Heritage NSW comments and recommendations on Response to Submission and Review of Aboriginal Cultural Values for the Glendell Continued Operations Project SSD-9349

Glendell Continued Operations Project

FIGURE 1

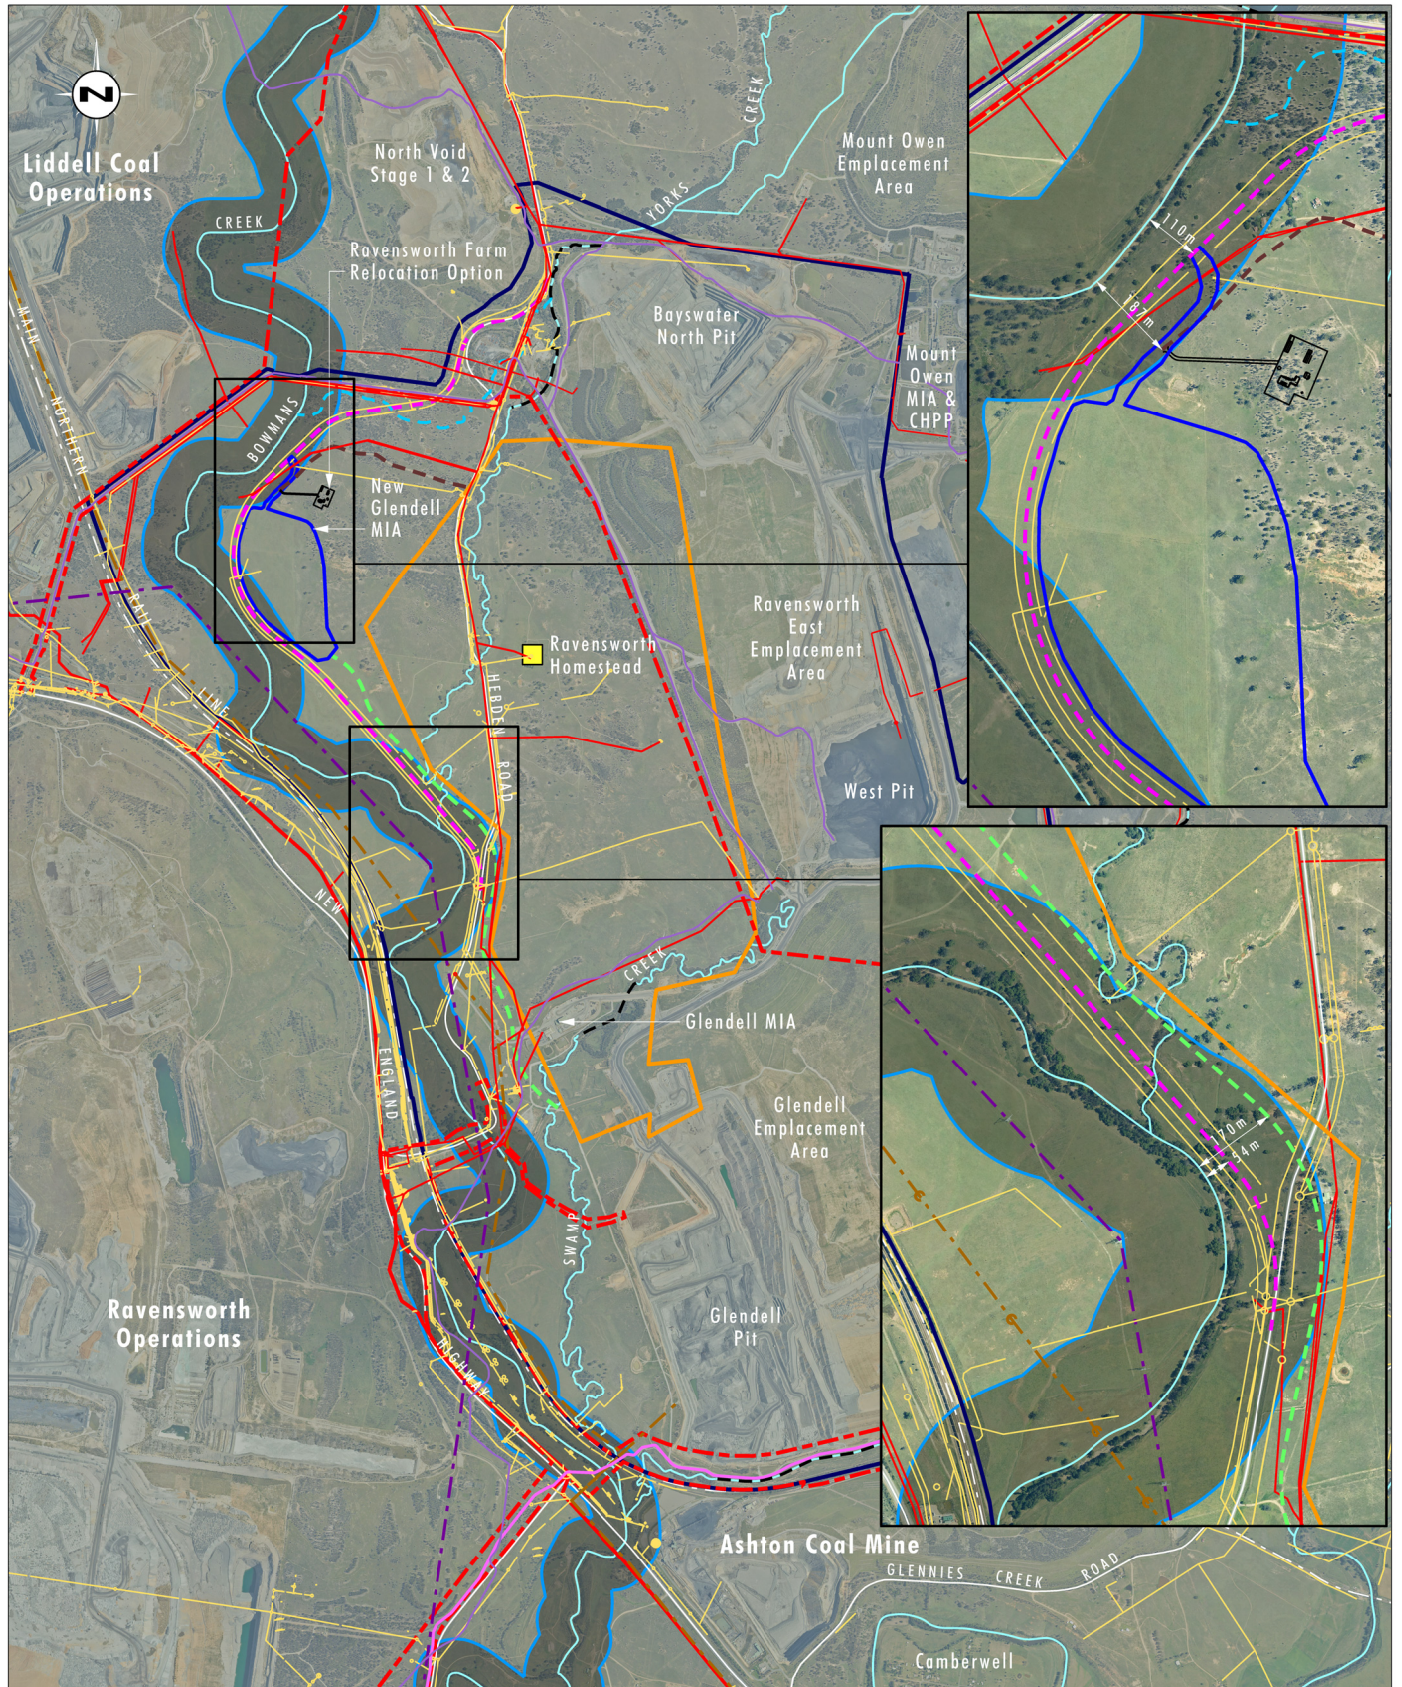
However, we note that the manner in which Heritage NSW Recommendation 2 is currently written implies that all works associated with the Project, including proposed infrastructure, are recommended to be situated a minimum of 200 metres from Bowmans Creek. The following proposed features of the Project are partially located within 200 metres of Bowmans Creek (refer to **Figure 1**):

- Hebden Road Realignment

- Heavy Vehicle Access Road
- Lower reaches of the proposed Yorks Creek Realignment
- Mine Infrastructure Area (MIA) and access road, including the intersection to the 'Ravensworth Farm Relocation Option' access road.

Of the above proposed features, the Heavy Vehicle Access Road and MIA will both be removed, and the areas are proposed to be rehabilitated following the cessation of mining.

The proposed infrastructure works are critical to the effective operation of the Project and the location and alignments have been optimised to minimise impacts, however the current wording of Recommendation 2 would preclude Glendell from carrying out these works.

Based on the information provided above, we suggest the Recommendation 2 should be removed to be consistent with the project design objective of having no mining within 200 metres of Bowmans Creek.

FIGURE 2

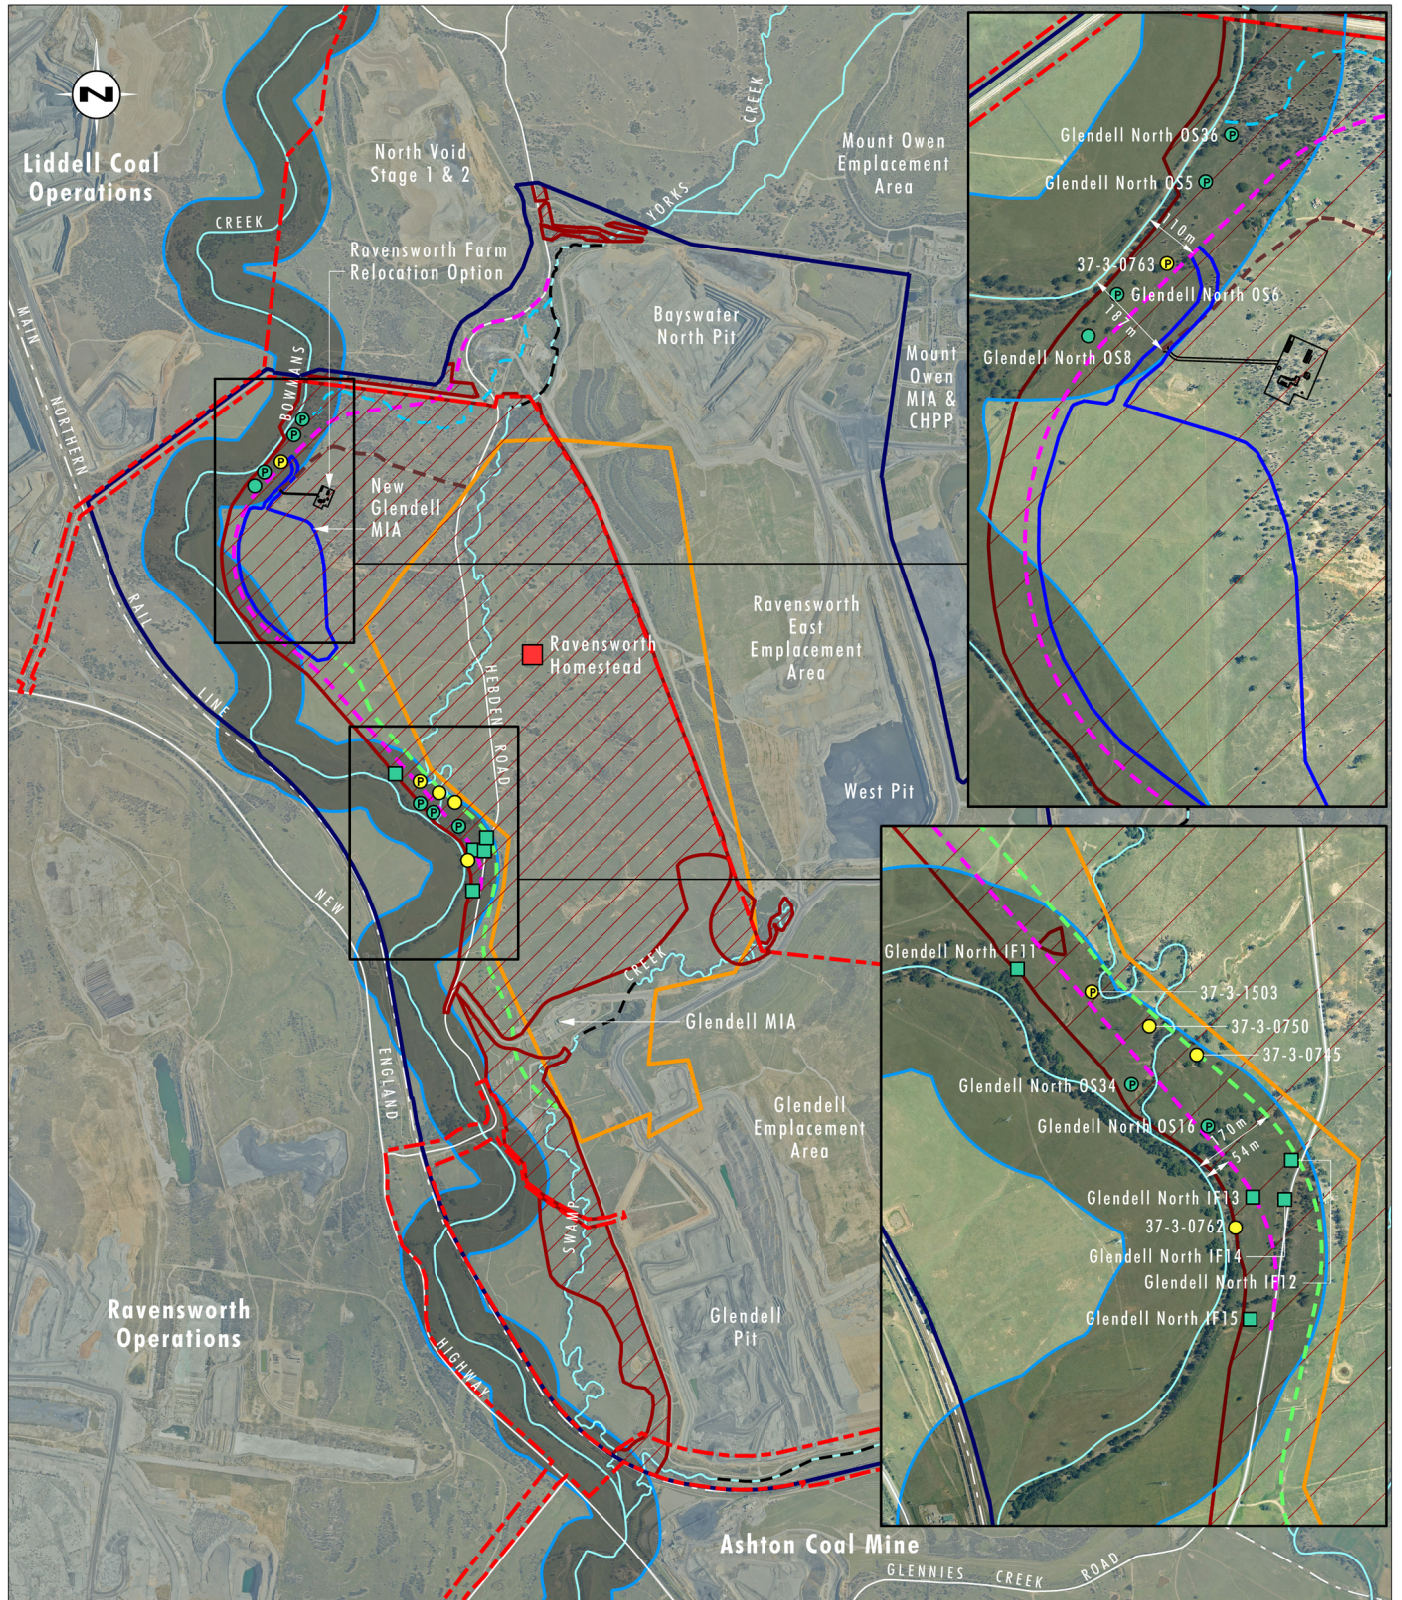
- The Aboriginal Archaeological Impact Assessment (AAIA) (Appendix D of Appendix 3 of RTS Part B report) provides an assessment of the Project's impacts in areas much closer to Bowmans Creek than 200 metres (refer to AAIA, Figures 1-5, 5-1 and 6-1). The Aboriginal archaeological sites identified within 200 metres of Bowmans Creek in the Additional Disturbance Area are shown on **Figure 2** and details are provided in **Table 1**. With regard to the Heritage NSW Recommendation 2 "*to avoid impact to significant Aboriginal sites*" it is noted that none of these sites to be disturbed within 200 metres of Bowmans Creek were categorised as being archaeologically significant. It is proposed that these sites will be recorded and salvaged prior to any ground disturbance works occurring in this vicinity, in accordance with an Aboriginal Cultural Heritage Management Plan to be developed in consultation with the project RAPs.

Figure 3: 1958 aerial showing historic disturbances within the Project Area

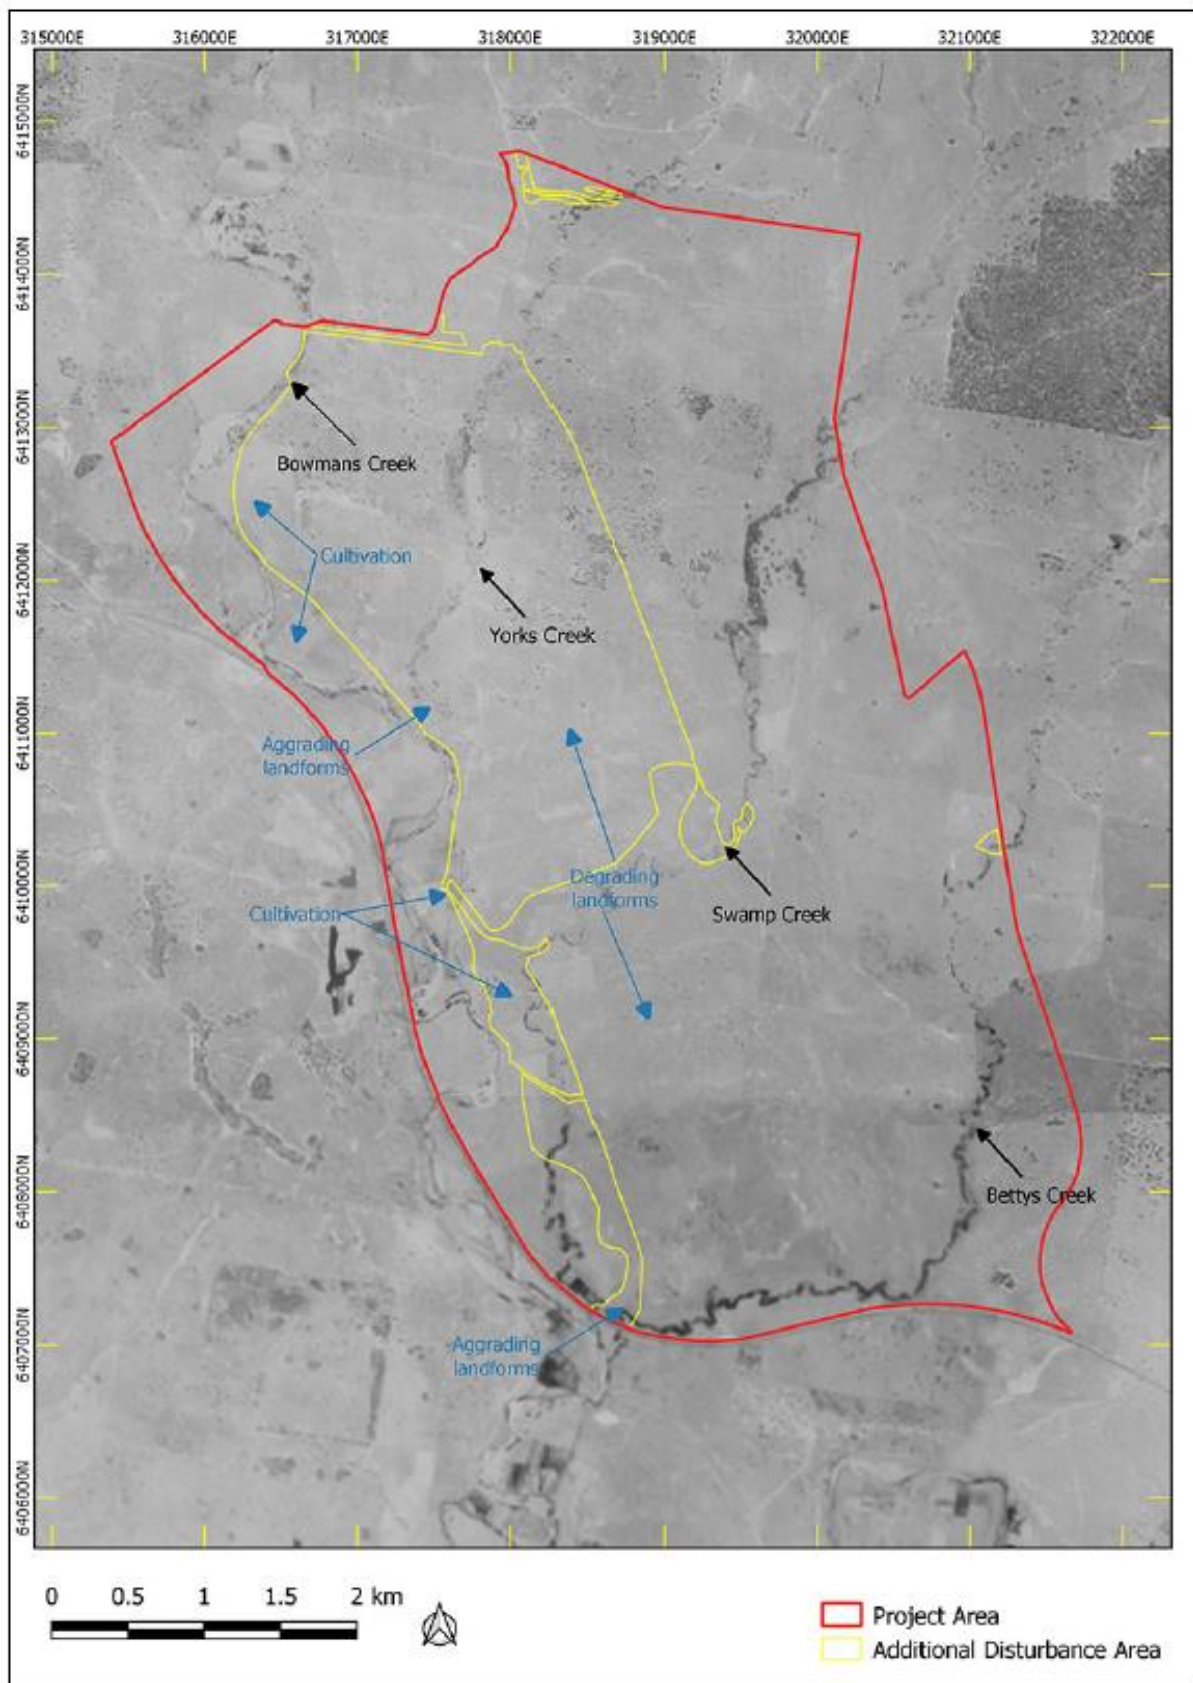
- Many areas within 200 metres of Bowmans Creek have been significantly impacted by past agricultural activities. As noted in the AAIA, the Additional Disturbance Area generally has a low gradient and has been subject to extensive clearing and cultivation in areas immediately adjacent to Bowmans Creek (refer to **Figure 3**), and most of the area remains cleared with large portions continuing to be used for cattle grazing. Further, the AAIA found that the historic disturbance which has occurred in the Additional Disturbance Area has led to the dissipation or removal of archaeological sites across the area, resulting in low average artefact density found during survey and the subsequent test excavation program (refer to discussion in Section 7.1.2 of the AAIA (Appendix D of Appendix 3 of RTS Part B report)).
